# ANN ARBOR BUILDING BOARD OF APPEALS

## STAFF REPORT

Building Board of Appeals Request **BBA21-004** at 115 W. Liberty Ann Arbor, MI

### Plan Review

FLOOR PLAN  
LEVEL 1

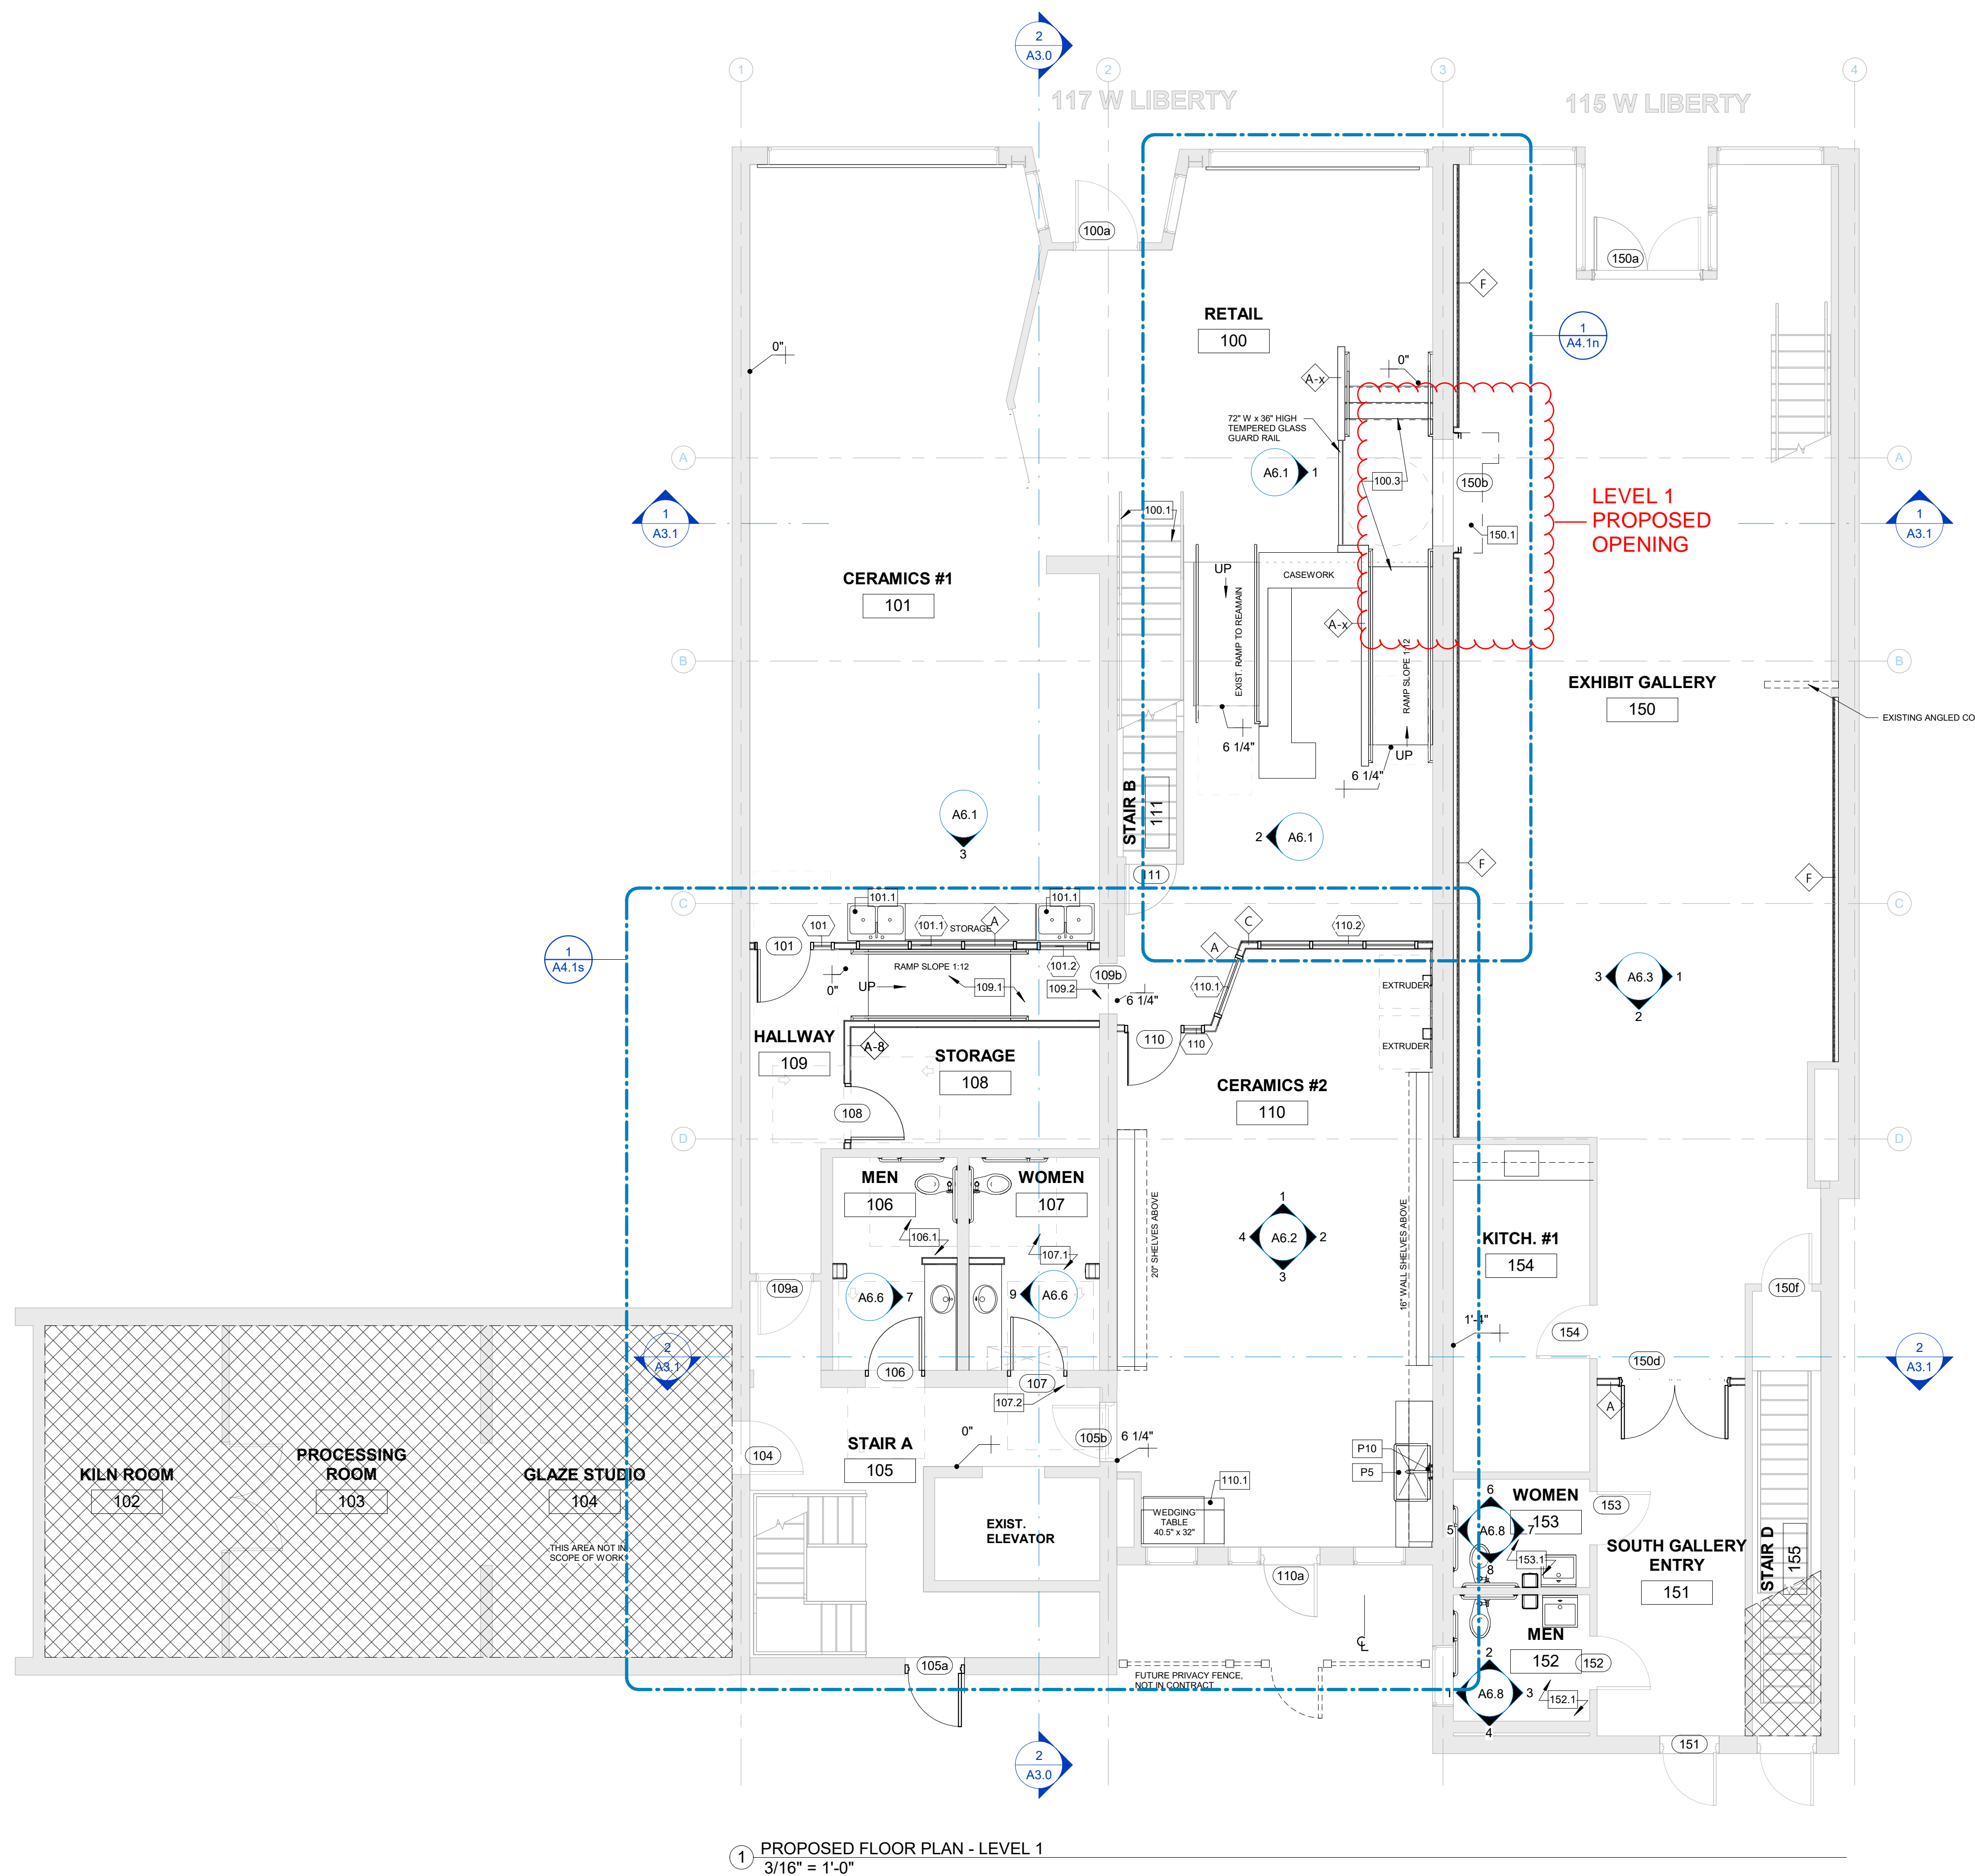
**Revisions required: Yes, See sheet A1.1 for door corrections. Also I am deferring this plan back to the City of action on the property line separating the 115 and 117.**
